APPLICATION NO.	FILING DATE	FIRST NAMED INVENTOR	ATTORNEY DOCKET NO.	CONFIRMATION NO.
10/554,267	10/24/2005	Yoshinari Takemura	59349.00043	2724
32294 759		EXAMINER		
SQUIRE, SANDERS & DEMPSEY L.L.P. 14TH FLOOR			ARCE DIAZ, MARLON A	
8000 TOWERS O TYSONS CORN			ART UNIT	PAPER NUMBER
	•		3611	
			MAIL DATE 12/12/2007	PAPER

DETAILED ACTION

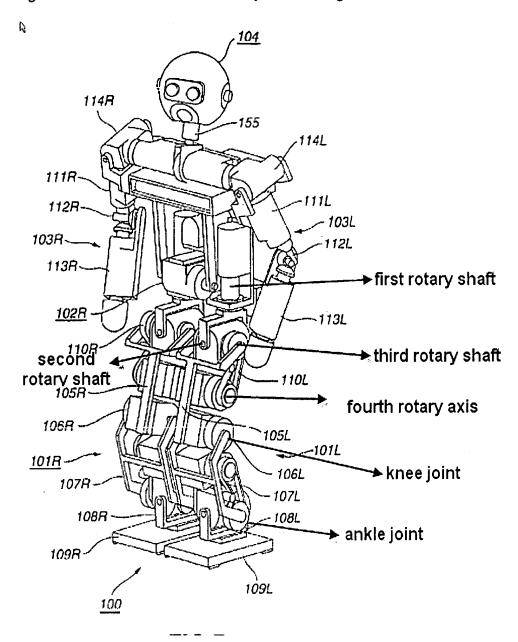
- 2. Claims 1,3,4,13 and 14 are rejected under 35 U.S.C. 102(e) as being anticipated by Hattori (US 6802382). Hattori discloses a robot moving on legs and control method comprising: a robot comprising a hip joint (Fig below) with a first rotary shaft (Fig below) that is the hip yaw axis (16), a second rotary shaft (Fig below) that is the hip roll axis (18), a third rotary shaft (Fig below) that is the hip pitch axis (17) and a fourth rotary Shaft (Fig below) that results in a degree of freedom; Hattori further discloses a knew joint (Fig below) and an ankle joint (Fig below). {{Examiner likes to point out that the figure seen below is indeed figure 7 in Hattori's}}. Regarding claim 3, the fourth rotary

shaft is in not parallel to the yaw axis as seen below. Regarding claim 4, the fourth rotary shaft is placed forwardly of the first shaft as seen in figure 8. Regarding claim 13, figure 8 also shows the first rotary shaft being offset in the direction of the roll axis.
